ADDENDUM NUMBER THREE

**USC Health Sciences Renovation
Project No.: U-676-09**

State Permanent Improvement Project No.: H27-6052-AC

DATE OF ISSUE: November 7, 2013

drawing no. P1.1

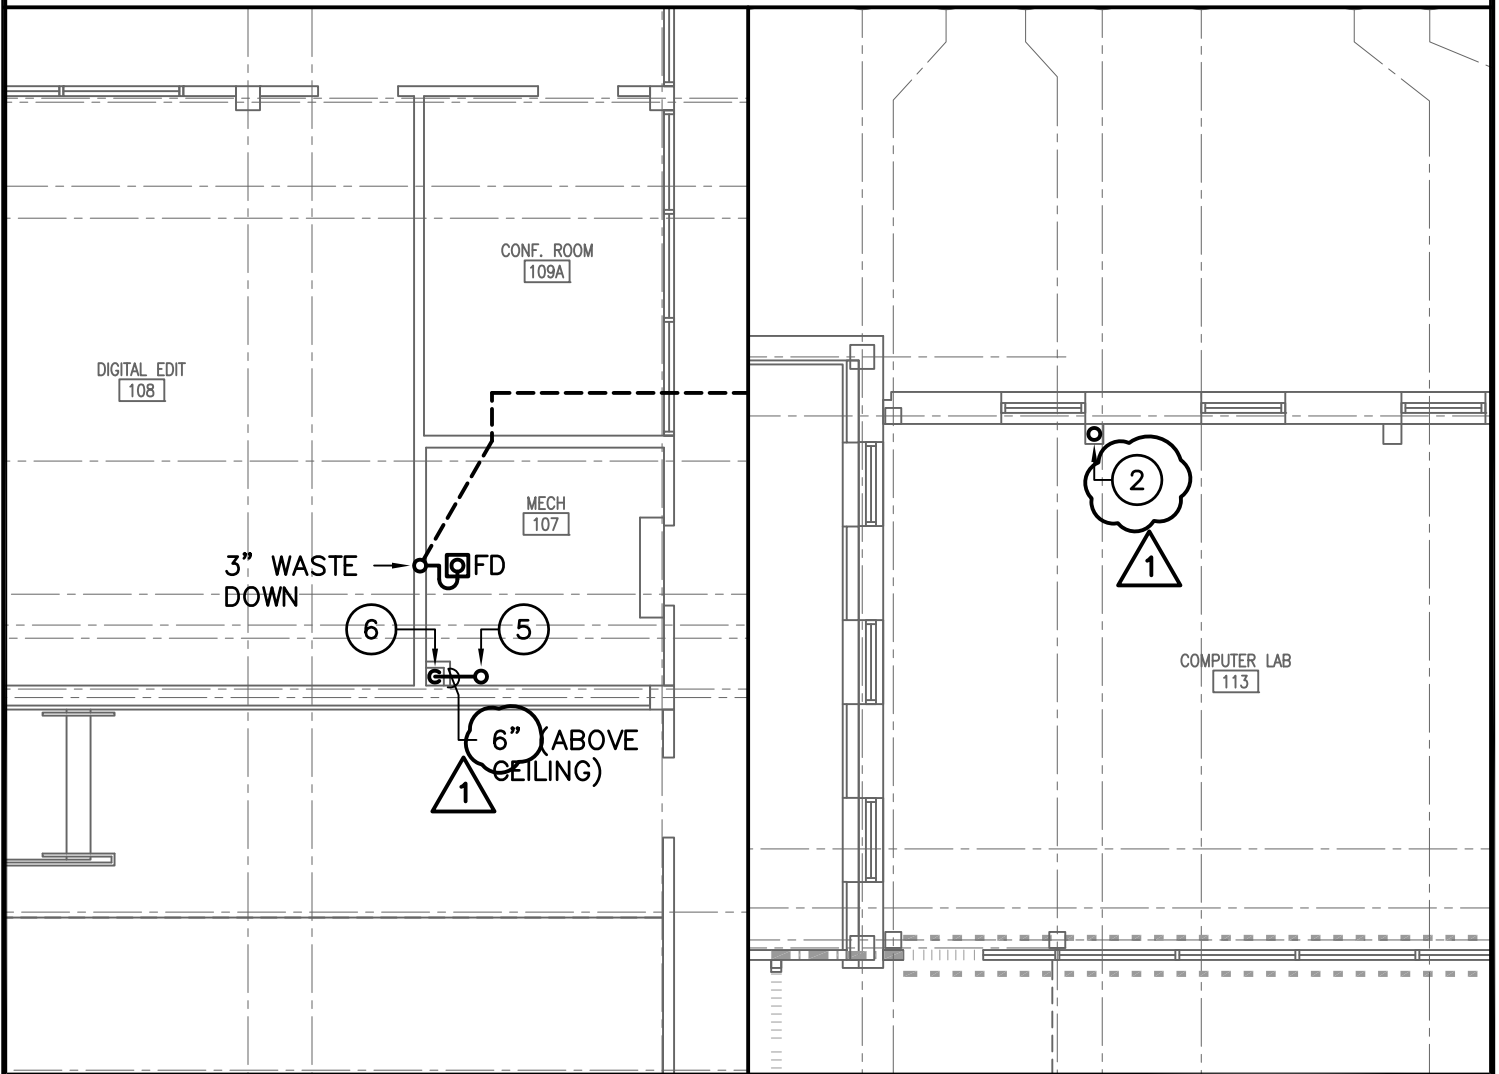
<u>Item No.</u>	<u>Description</u>
1.	<u>Refer to Drawing P1.1</u> Refer to the attached sketch, SK-P-2. This sketch changes some of the storm drain line sizes that were mislabeled on Sheet P1.1.
2.	<u>Refer to Drawing P1.2</u> Refer to the attached sketch, SK-P-3. This sketch changes some of the storm drain line sizes that were mislabeled on Sheet P1.2.
3.	<u>Refer to Drawing P1.3</u> Refer to the attached sketch, SK-P-4. This sketch changes a storm drain line size that was mislabeled on Sheet P1.3.
